MEMORANDUM

RE: Variance Request P2017-0150, Camp Majano LLC

OVERVIEW OF VARIANCE REQUEST

On August 17, 2017, the applicant provided the following schematic drawing with a handwritten note (Exhibit A) depicting the location of the proposed deck (Lower Deck Plan):

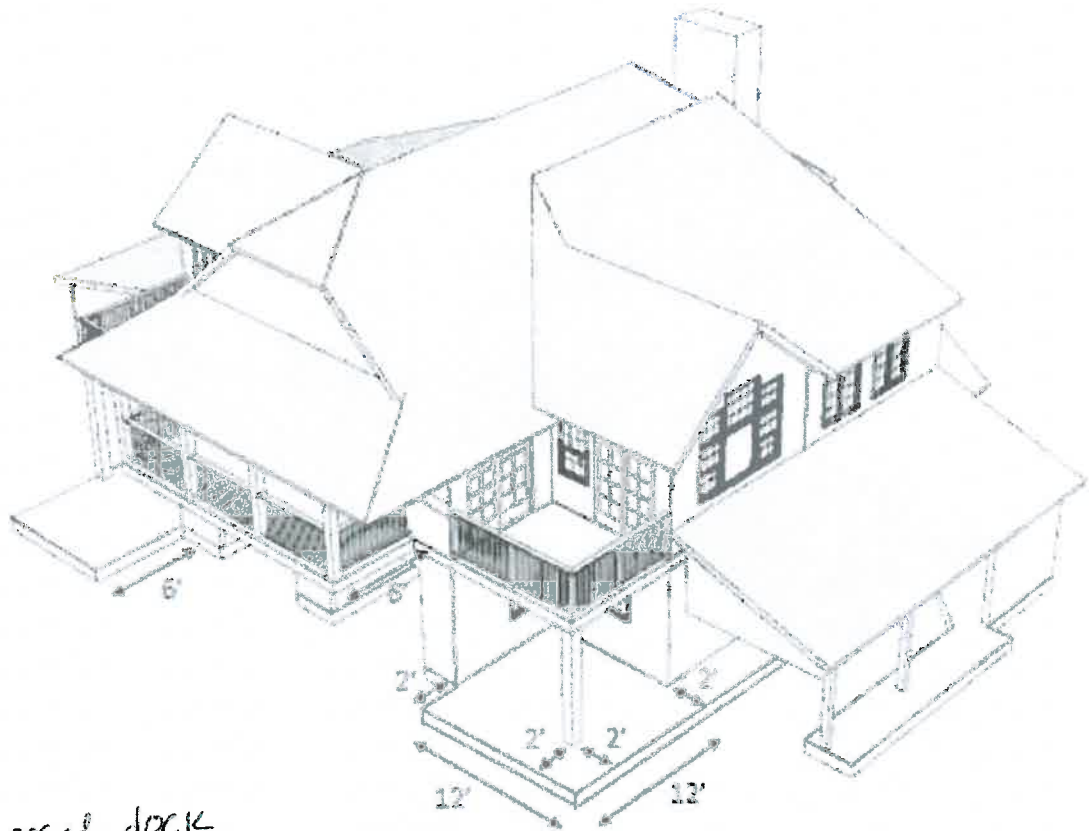
proposed deck
extends 2' past structure.
Above ^{pre-existing} center deck extends 6' past
structure. Existing East deck
extends 6' past structure.

The applicant could minimize the size of the requested deck by not extending the deck two feet further into the lake beyond the existing steel tiebacks. The resulting deck would be 10 feet by 12 feet in size rather than 12 feet by 12 feet, a reduction of 24 square feet. This smaller deck would address the applicant's safety concerns by covering the tiebacks and aligning the west edge of the deck with the boatslip. Facing the steel tiebacks and caissons with wood would also address the applicant's aesthetic concerns.
